City of Albuquerque

RE: REVISED DRAINAGE PLAN FOR LOT 15 OF RICHFIELD INDUSTRIAL PARK
(C-17/D2A3) REVISION DATE OF APRIL 3, 1989

DESIGNED BY: R.G.	RICHFIELD INDUSTRIAL PARK LOT 15 GRADING and DRAINAGE PLAN
DRAWN BY: B.G.	
CHECKED BY: E.D.	
DATE: MAR. 1989

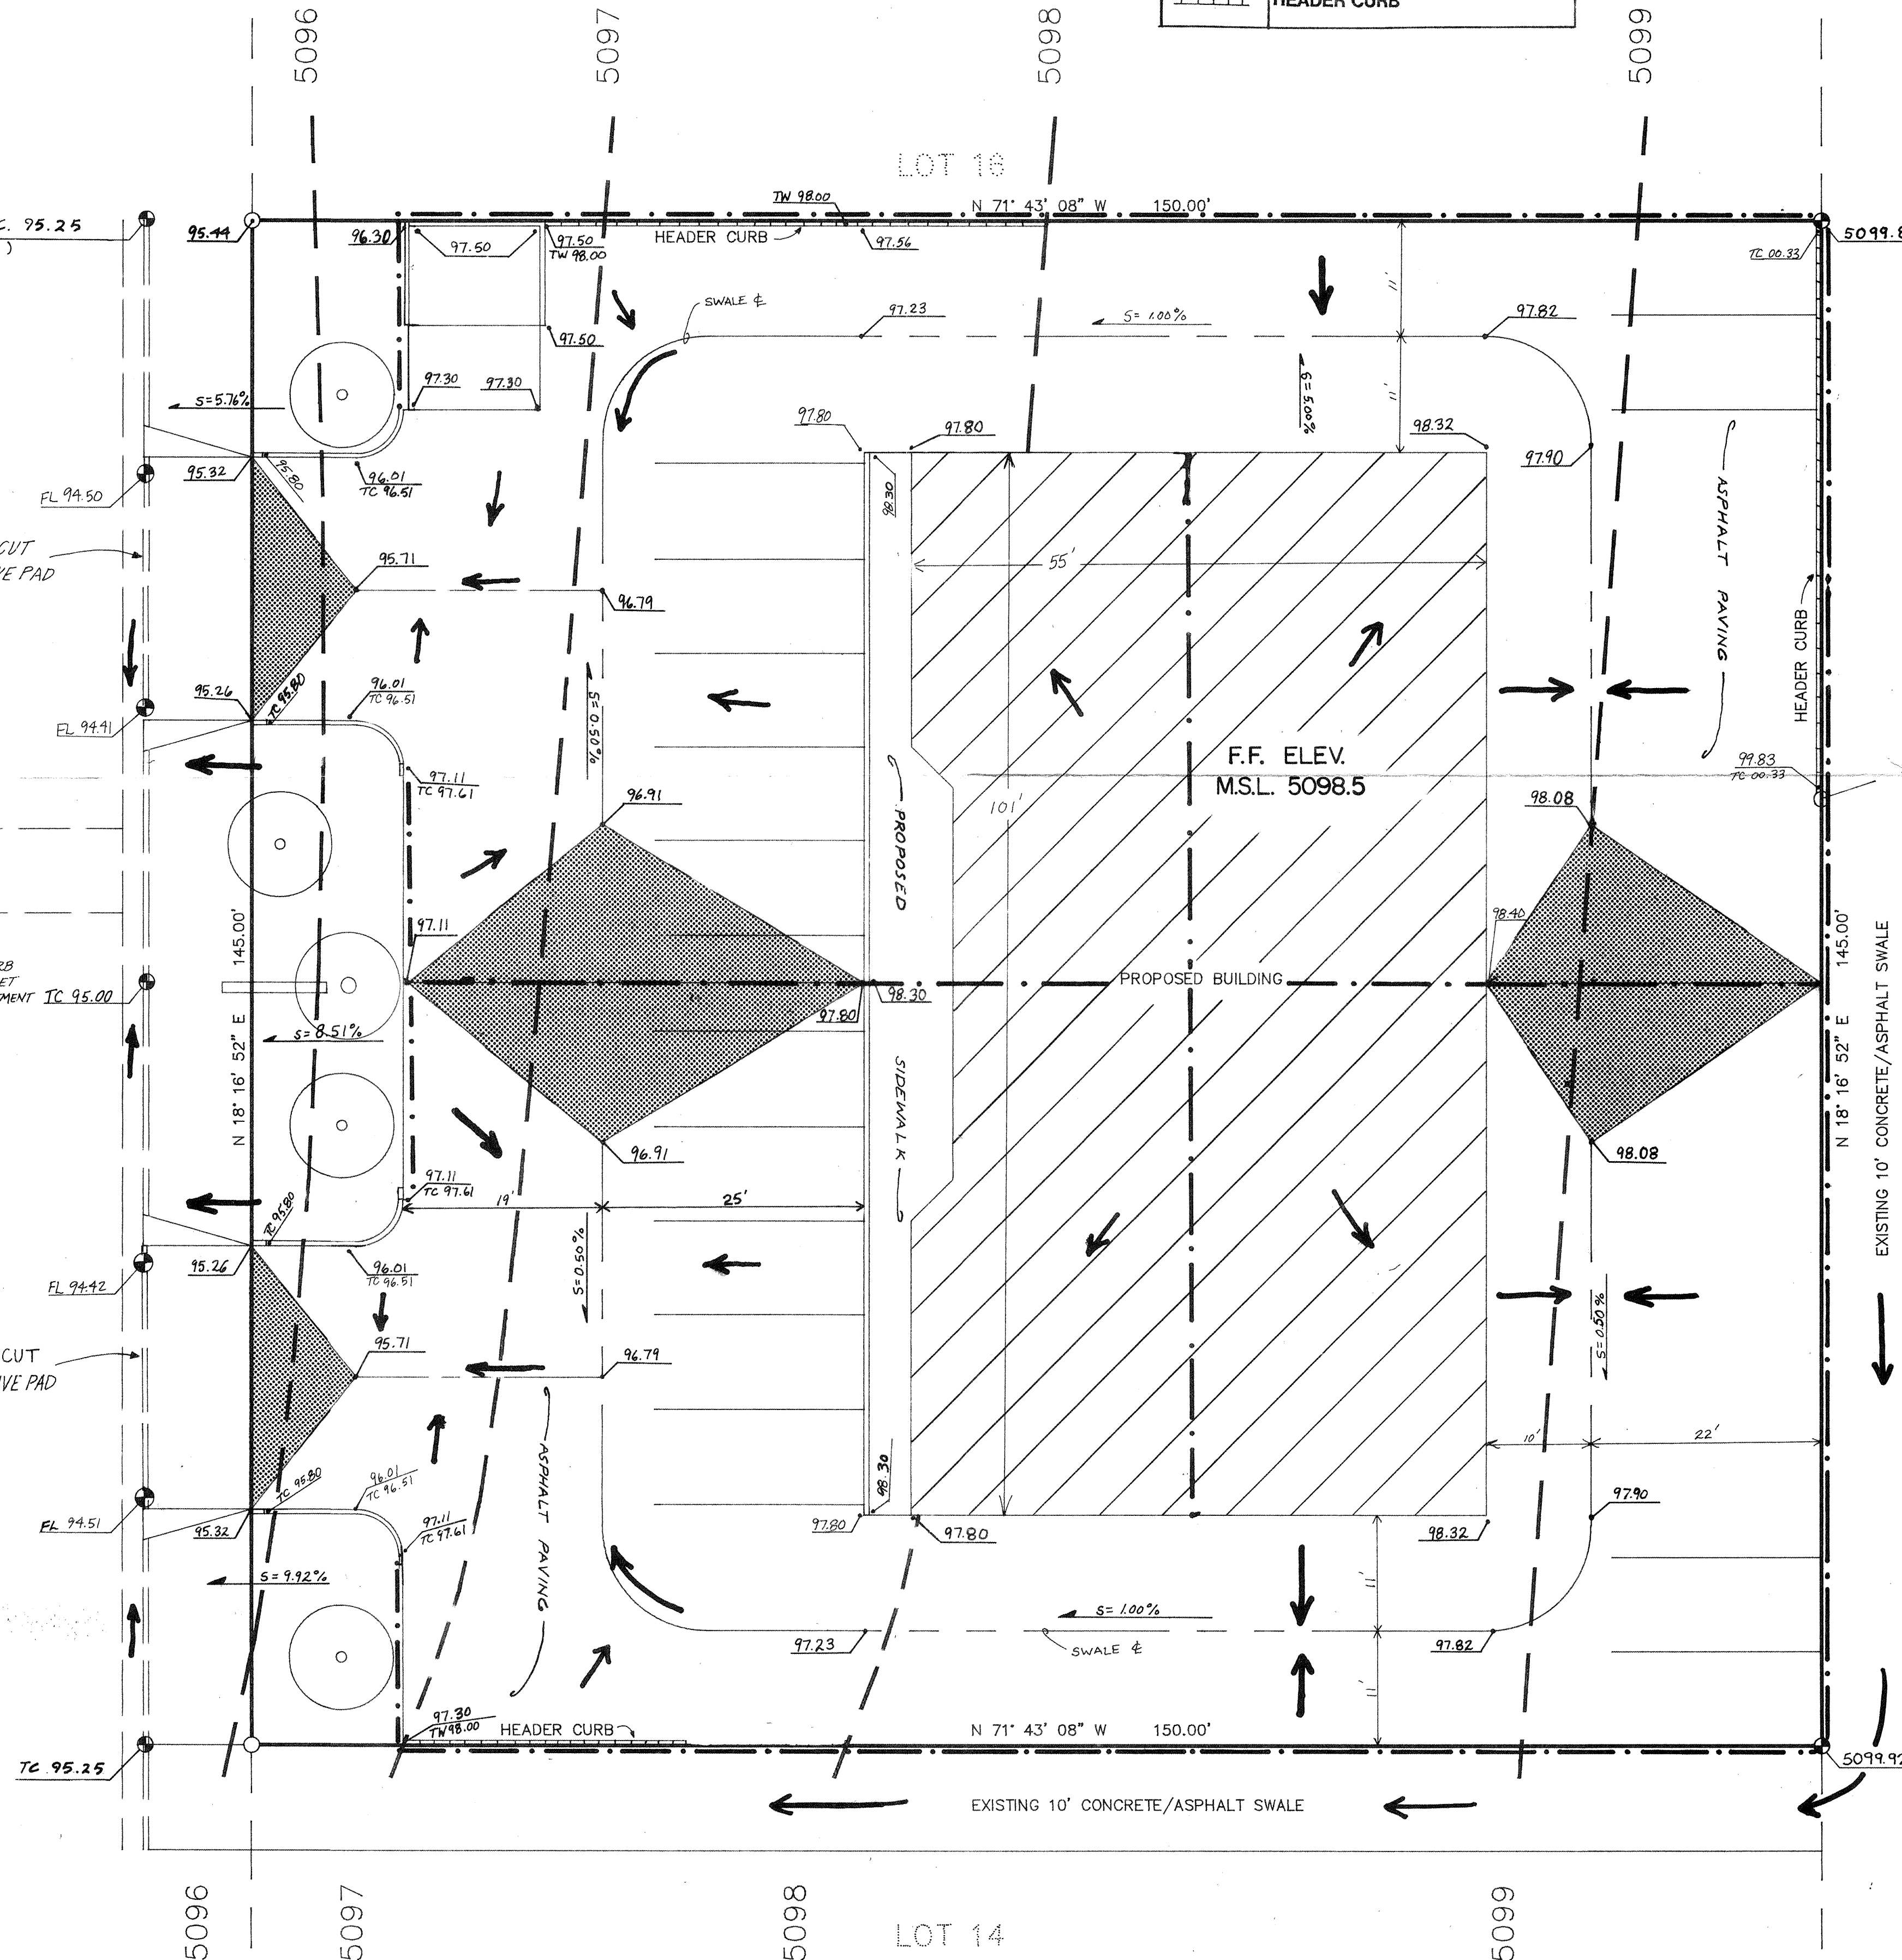
Based on the information provided on your resubmittal of April 4, 1989,
the above referenced plan is approved for Building Permit.

Please attach a copy of this plan to the construction sets prior to
sign-off by Hydrology.
